SUBJECT: WOLF CREEK GENERATING STATION - NRC EXAMINATION REPORT
05000482/2011301

Docket: 50-482
License: NPF-42
Report: 05000482/2011301
Licensee: Wolf Creek Nuclear Operating Corporation
Facility: Wolf Creek Generating Station
Location: 1550 Oxen Lane NE
Burlington, Kansas
Dates: August 26, 2011 - September 22, 2011
Inspectors: C. Osterholtz, Senior Operations Engineer
D. Strickland, Operations Engineer
T. Farina, Operations Engineer
Approved By: Mark Haire, Chief
Operations Branch
Division of Reactor Safety

ER05000482/2011301; August 26, 2011 - September 22, 2011; Wolf Creek Generating Station; Initial Operator Licensing Examination Report; Examination Development

Question 85

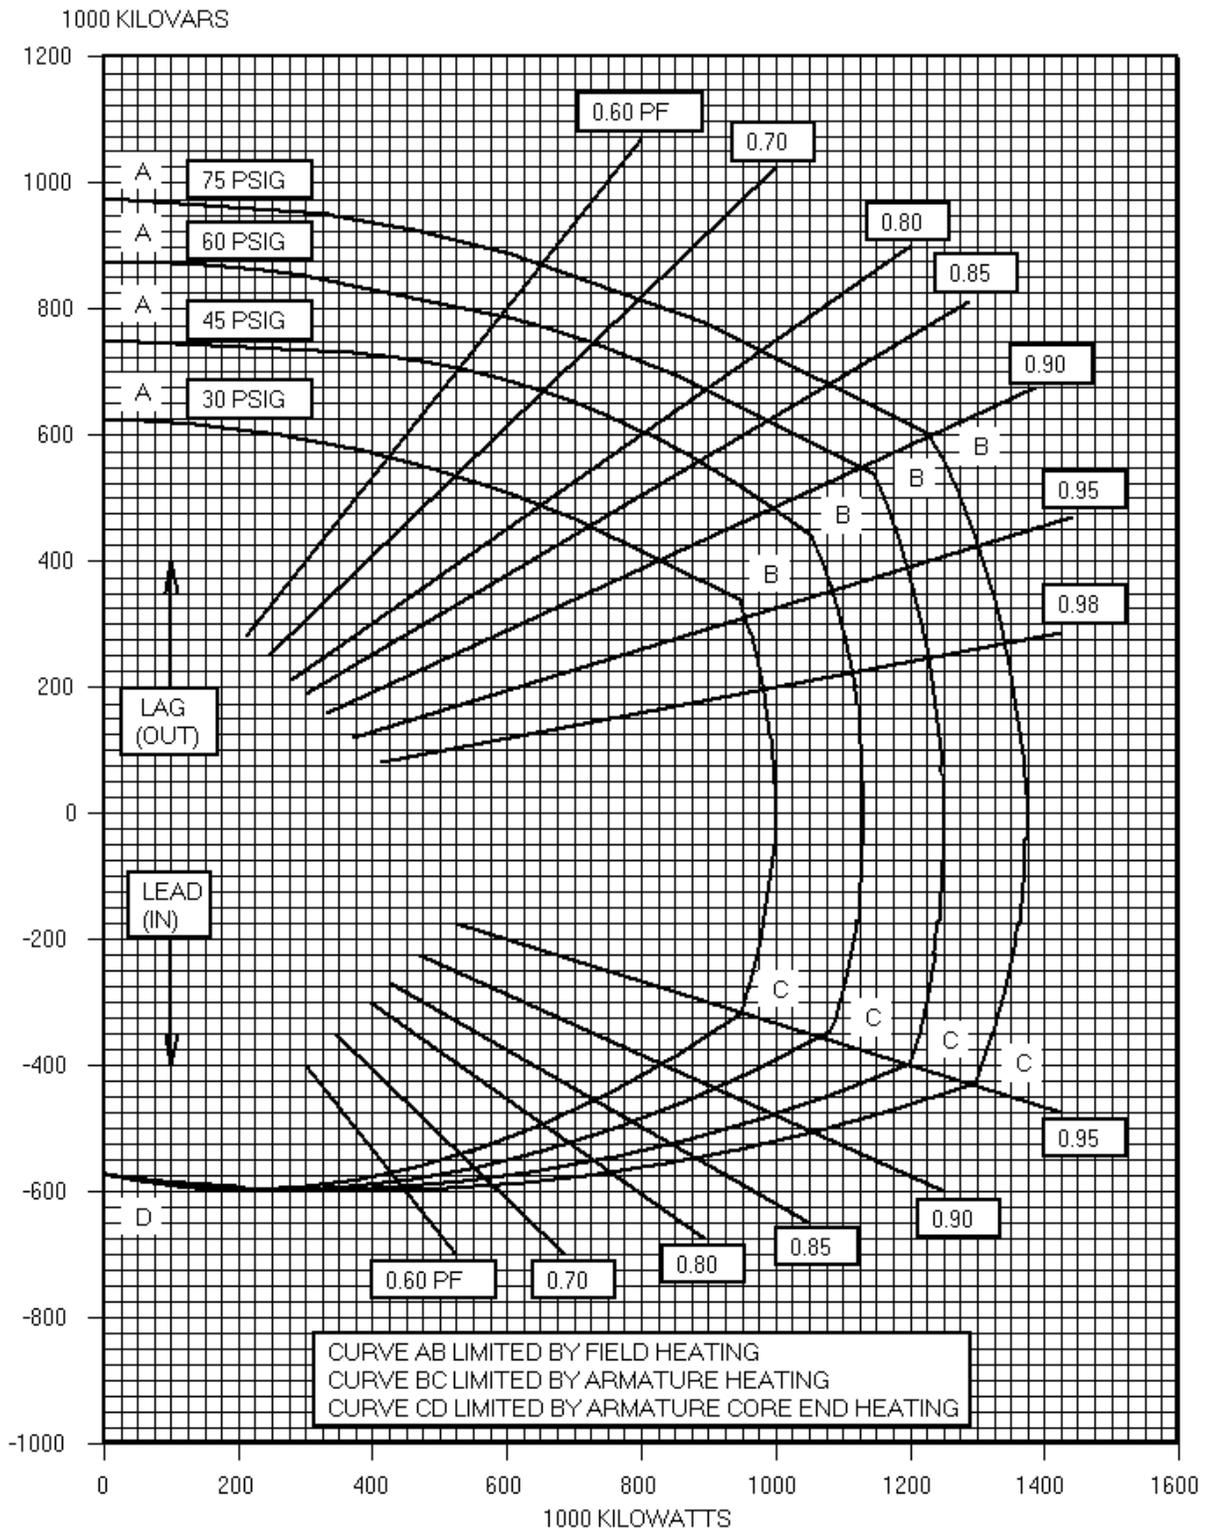
Question 85 is a new question. This question was missed by 7 of 8, with all choosing answer B. One post-exam comment received from an applicant asked why initial conditions existed in the stem when all answers had their own conditions. Another post-exam comment stated the answer was still higher than the line, but that they chose the one that was closest to the graph line. There were no misses during validation, but the question was changed in the final revision. The original draft answers were based on pressure and power factor. The NRC requested a change to MVAR loading since power factor is not a measured quantity on the control board indications. The question was redrafted, technically reviewed and revalidated by two licenses. They both missed it. The question was changed again based on their feedback and an error occurred in the final revision.

The question is two parts, the first part assesses main generator limitations and the second the required course of action to place the unit in a safe configuration. The applicant must find four points on the main generator spider curve and assess whether they are inside or outside of an acceptable pressure curve. This was first done with pressure versus power factor then later revised to pressure versus reactive load. The second part tests the applicant's knowledge of the required remedial actions contained in ALR vice OFN procedures.

Review of the associated points indicates there is no correct answer to this question since all points are outside their respective power curves on the figure. The question prior to the final version did have a correct answer with reactive load in Answer D at 400 MVAR. This was changed to 500 MVAR in the final version by a validator comment. This change was made in error without sufficient final review.

Answer B is closest to the curve but still outside. The procedural flowpath is incorrect since the OFN does not isolate the leak. The leak is isolated by the local ALR, which then sends the performer to a system operating procedure to emergency depressurize the generator.

The question requires repair. The original question may not have been discriminatory enough, but performed well in validation. If MVAR is to be used in the answer then the current MVAR loading statement needs to be removed from the stem. A correct answer must be provided.

This question is recommended for deletion from this exam because no correct answer is provided. For this question, an error occurred when changes were incorporated from validation without sufficient technical review.

The examiners concurred with the licensee's assessment. When the question was converted to have the distracters read in MVARs rather than power factor, an error was incorporated into the question that rendered none of the distracters correct.

Since there is no correct answer, the final answer key has been revised to indicate that this question has been deleted from the examination.
